Product Change Notice (PCN)

PCN Number: **PCN-0454917R-01**

Product(s) Affected: *PJ-085AH*

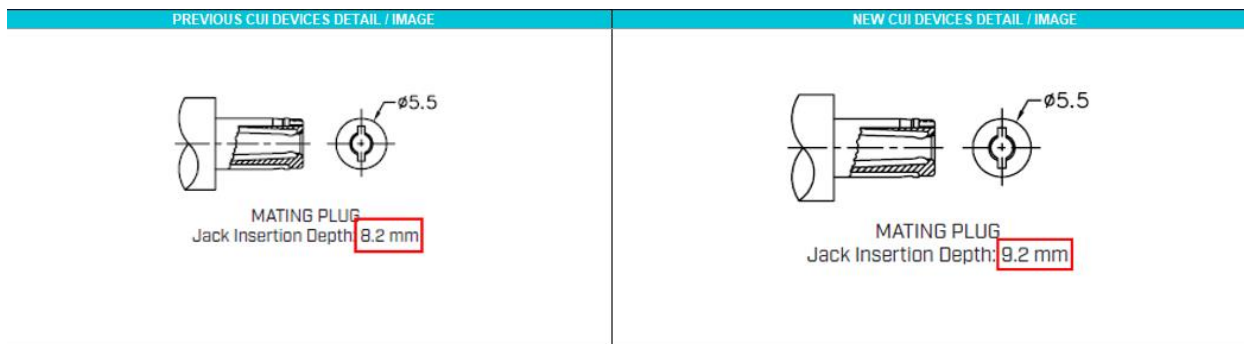
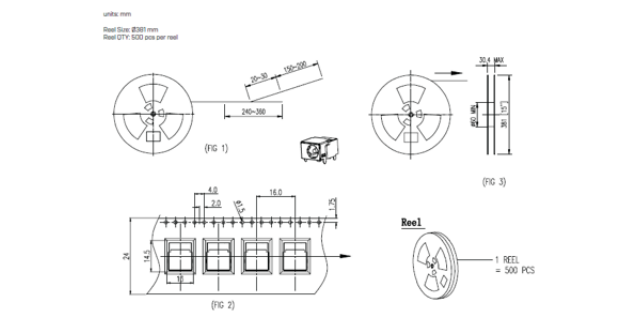
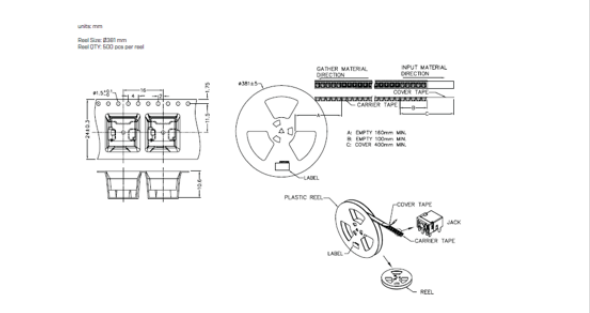
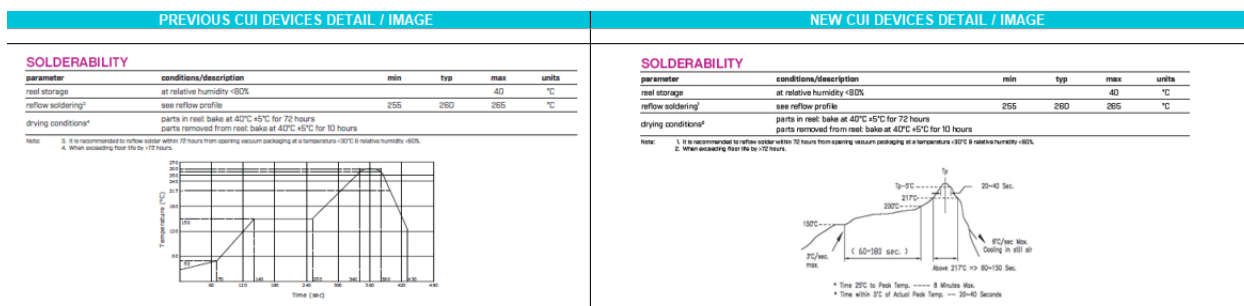
Description of Change: *Minor Housing and footprint differences. Material Change on the housing and terminals. See image Below*

MATERIAL	PLATING
center pin	copper	nickel
terminal 1	brass	silver
terminal 2	copper alloy	silver
terminal 3	brass	silver
terminal 4	copper alloy	silver
shield A	brass	nickel
shield B	stainless steel	
insulator	PA10T

DESCRIPTION	MATERIAL	PLATING
center pin	brass	nickel
terminal 1	brass	silver
terminal 2	phosphor bronze	silver
terminal 3	brass	silver
terminal 4	phosphor bronze	silver
shield A	brass	nickel
shield B	stainless steel	clean
housing	PA10T (UL94V-0)	black
